FACILITY AMENDMENT CLASSIFICATION - DOCKET NO(S). 50-261

Plant Name and Unit(s): ROBINSON 2

H. B. ROBINSON STEAM ELECTRIC PLANT, UNIT NO. 2
DOCKET NO. 50-261
LICENSE NO. DPR-23
ISOLATION VALVE SEAL WATER SYSTEM

ISOLATION VALVE SEAL WATER SYSTEM

FIGURE 1

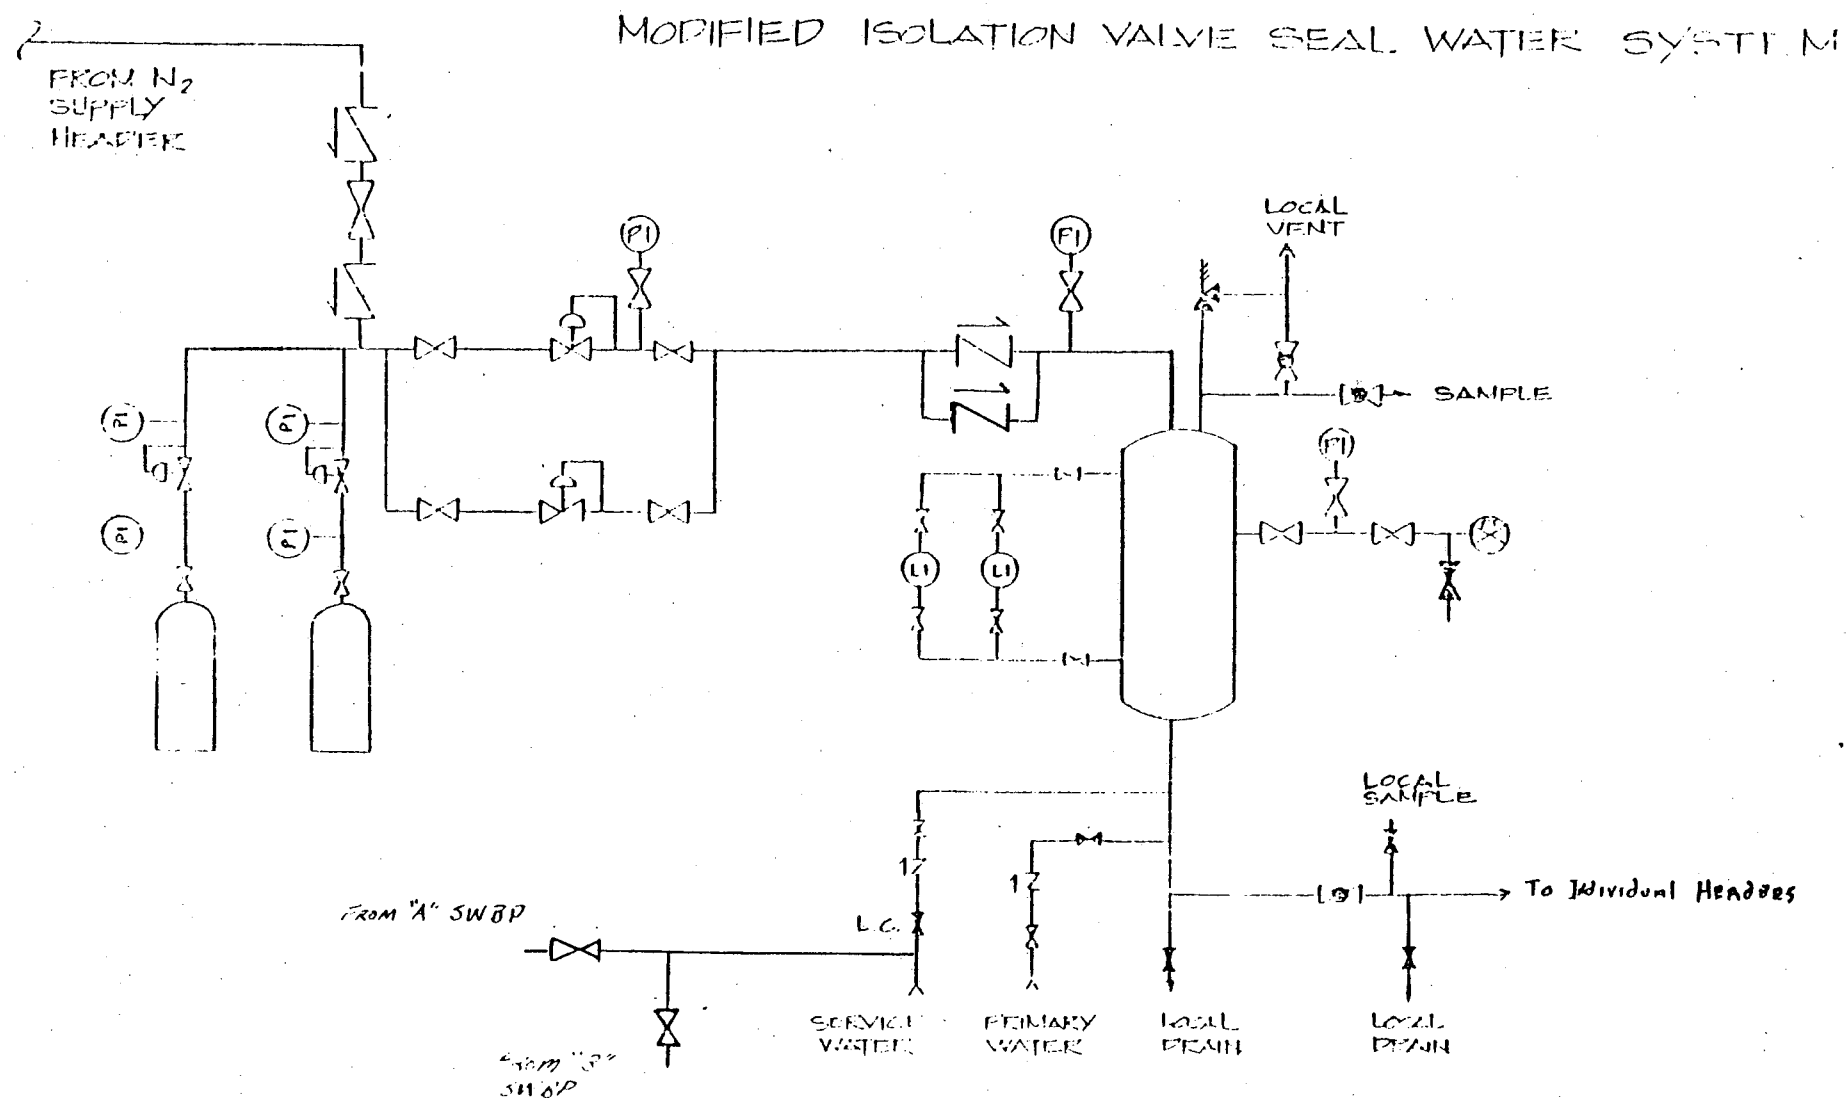
Attached to this letter is a description of the H. B. Robinson IVSW system. Our review over the last few months has indicated minor changes which will further enhance the reliability of the IVSW system. These changes will be made during the next refueling outage. Both the present and the proposed systems are shown in the attached figures (Figure 1 and Figure 2 respectively). These changes do not in any way constitute an unreviewed safety concern, and we are not asking for approval for the specific changes or credit for the seal functions of the system with regard to our dose calculations.

The present Isolation Valve Seal Water System flow diagram is shown in Figure 1. Changes to the system to increase its reliability are presented on Figure 2. These changes will be performed during the next refueling outage. Additional information is presented in Chapter 5 of the H. B. Robinson FSAR.
